**ENGINEERS INDIA LIMITED**  
 (A Govt. of India Undertaking)  
**HINDUSTAN PETROLEUM CORPORATION LTD**  
**VISAKH REFINERY**  
**VISAKH REFINERY MODERNIZATION PROJECT**  
 CLG LC-MAX TECHNOLOGY & ISDTREATING TECHNOLOGY  
 HOT OIL BLOWDOWN DRUM, 504-V-807  
 RESIDUE UPGRADATION FACILITY (RUF)  
 VISAKH REFINERY MODERNIZATION PROJECT (VRMP)  
 HINDUSTAN PETROLEUM CORPORATION LIMITED  
 VISAKHAPATNAM, ANDHRA PRADESH, INDIA  
 BD-175582

<b>Residue Upgradation Facility (RUF)</b> <b>EPCC-3 Package for</b> <b>Visakh Refinery Modernization Project (VRMP)</b>	 <i>L&amp;T Hydrocarbon Engineering</i>
		<b>L&amp;T-CHIYODALIMITED</b>
<b>Title: Process Datasheet for HOT OIL BLOWDOWN DRUM (504-V-807)</b> <b>Doc. No.: B016-RUF-LT-504-PC-DS-0288</b>		<b>Rev. No.: 0</b> <b>Page No: 1 of 4</b>

**ANNEXURE – 1****CHANGE LIST**

**General:** This document is based on Licensor datasheet for HOT OIL BLOWDOWN DRUM (504-V-807) issued with bid. Document is further updated based detail engineering requirements (refer Change List below for details).

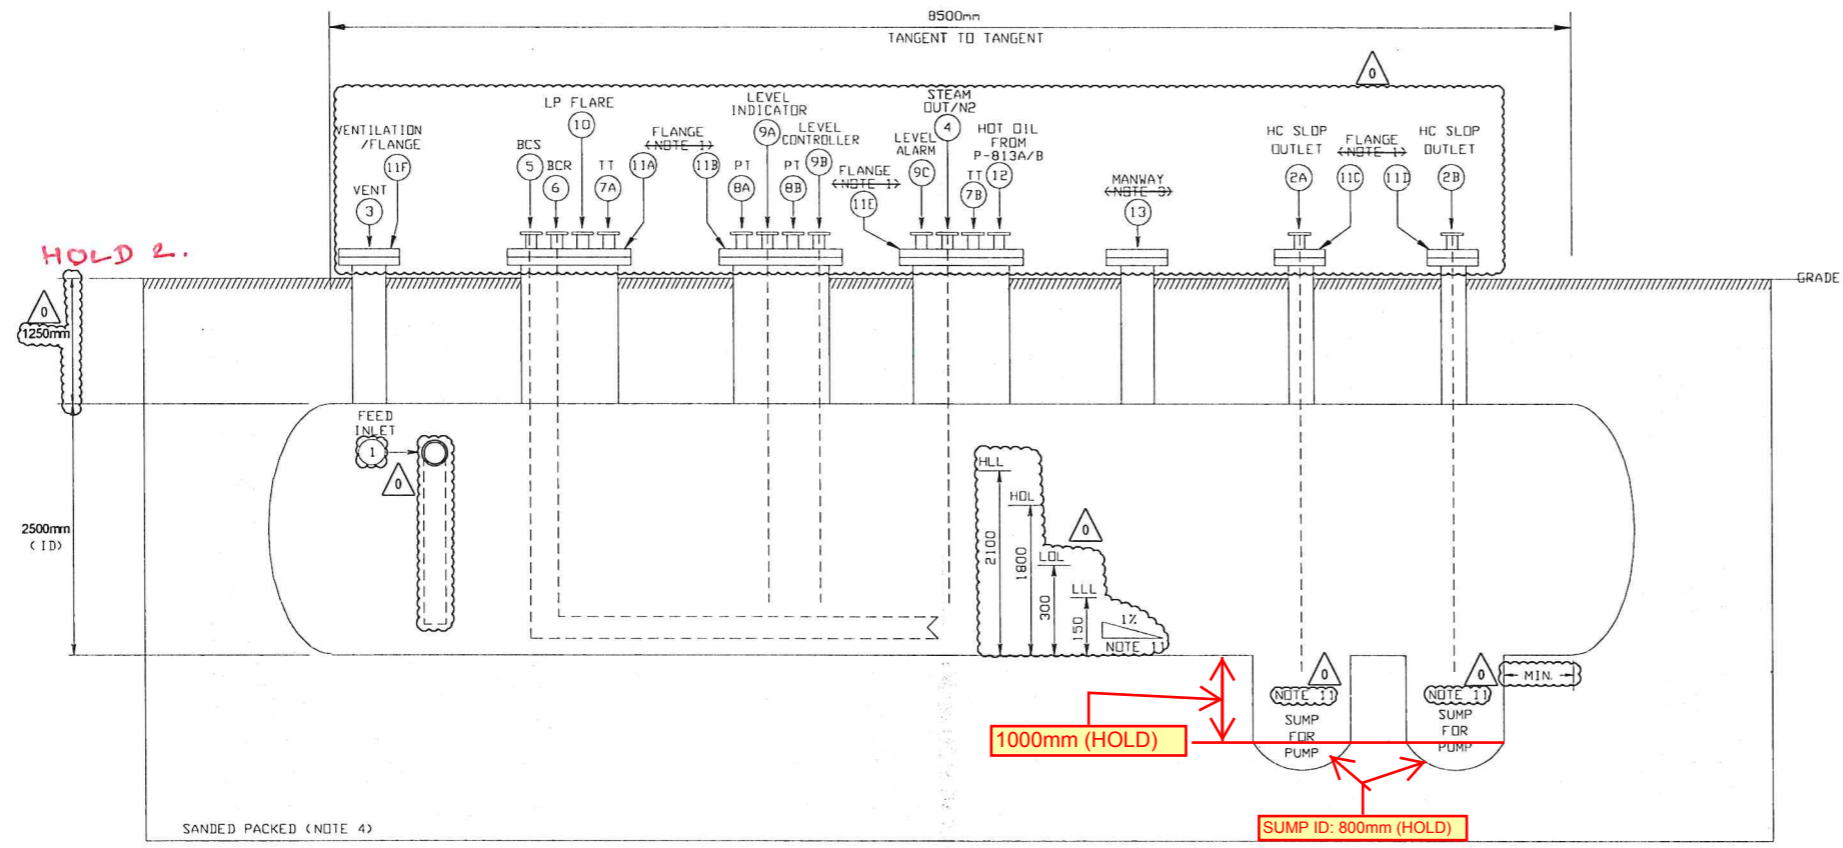
Sr. No.	Page No.	Description of change	Reference / Remarks
1.	2	Flanges numbers revised and sizes are defined in nozzle details & corresponding Note 1 is updated.	As per flange design input by Mechanical department. For detail refer mechanical engineering drawing. Number of flanges and detail will be updated in Rev 1 of P&ID: B016-RUF-LT-PID-504-11820.

2.	2	Nozzle numbering is added to nozzle details and on vessel sketch.	For better clarity on nozzle identification. It will be updated in Rev 1 of P&ID: B016-RUF-LT-PID-504-11820.

3.	2	Vent (#3) & steam out nozzles (#4) sizes are confirmed as 2” each as vessel is non-cladded, in nozzle details & corresponding Note 2 is updated.	Reference to EIL BEDB Part B clause 8.5.3.3 (“A758-999-02-41-ODB-1001” pg. 73 of 115).

4.	2	Manway nozzle (#13) size (24”) & location is confirmed & corresponding Note 3 is deleted.	<ol style="list-style-type: none"> <li>1. Location is at top of shell of horizontal vessel. Final location will be decided by Mechanical engineering based on piping. There is no other Process engineering input required.</li> <li>2. Manway size is defined based on EIL BEDB (Part-B) clause 8.5.3.3 A758-999-02-41-ODB-1001 pg. 73 of 115. Missing man-way will be updated in Rev 1 of P&amp;ID: B016-RUF-LT-PID-504-11820.</li> </ol>

5.	2	Drum location w.r.t ground level is defined on	Relative elevation of drum is provided as per piping input considering

Sr. No.	Page No.	Description of change	Reference / Remarks
		vessel sketch and corresponding Note 4 is modified.	slope of feed inlet header to the vessel.

6.	2	Nozzle (#12) is added for hot oil from pitch solidification area.	To keep it in-line with P&ID: B016-RUF-LT-PID-504-11820 (Rev 0).
7.	2	Feed nozzle (#1) update the location.	The feed nozzle was fouling with knuckle of vessels while placing it above HLL. Hence, the feed nozzle was shifted to shell as marked based on input by Mechanical department.

8.	2	Ventilation/Vent nozzle (#11F) updated to Ventilation/Flange nozzle and Vent nozzle #3 defined separately.	As per mechanical department input, Ventilation nozzle is considered as flange. For further details, please refer Mechanical Engineering Drawing.

9.	2	Cooling water supply and cooling water return word is changed to Bearing cooling water supply (#5) and Bearing cooling water return (#6) respectively in nozzle detail table. Also corresponding changes made in sketch and note 5 i.e. CWS and CWR changed to BCS and BCR.	To keep it in-line with P&ID: B016-RUF-LT-PID-504-11820 (Rev 0).

10.	2	Level tap nozzle (#9A-C) size is defined as 4" for radar type.	As per Instrument design basis & EIL guidelines in doc. no. B016-504-16-EDB-95097-52-0001.

11.	2	Liquid level nomenclature is modified on vessel sketch for better clarity on level identification.	As per EIL guidelines in BEDB (Part-B) Abbreviations on pg. 11 of 115 A758-999-02-41-ODB-1001.

12.	2	High Liquid Level (HLL) is revised from 2200mm to 2100mm. Low liquid level (LLL) is defined as 150 mm.	To place the Feed nozzle above HLL, the HLL was reduced. The total pumpable volume between HLL and LLL is ensured as 40 m <sup>3</sup> as specified in EIL BEDB (Part-B) clause 6.8.2 pg. 44 of 115 A758-999-02-41-ODB-1001. For detail calculations, please refer Annexure 2.

Sr. No.	Page No.	Description of change	Reference / Remarks
13.	2	Slope is defined as 1% inside vessel and corresponding Note 11 is added.	To drain towards sumps as per good engineering practice. It will be updated in Rev 1 of P&ID: B016-RUF-LT-PID-504-11820.
14.	2	Sump and pump discharge nozzle location is changed in vessel sketch and corresponding Note 11 is added.	Location of sumps is towards sloping end of vessel and minimum from TL. Location is changed in order to ensure complete draining of vessel due to slope.
15.	2	Sanded Packed Note 3 changed to Note 4 in vessel sketch.	To provide correct reference of Note 4.
16.	2	Trim added as Note 9.	As per PMS of inlet and outlet lines indicated in P&ID : B016-RUF-LT-PID-504-11820 (Rev 2)
17.	2	MDMT of 12.5 °C added in Note 10.	As per EIL guidelines in BEDB (Part-B) clause 4.2 pg. 22 of 115 A758-999-02-41-ODB-1001.
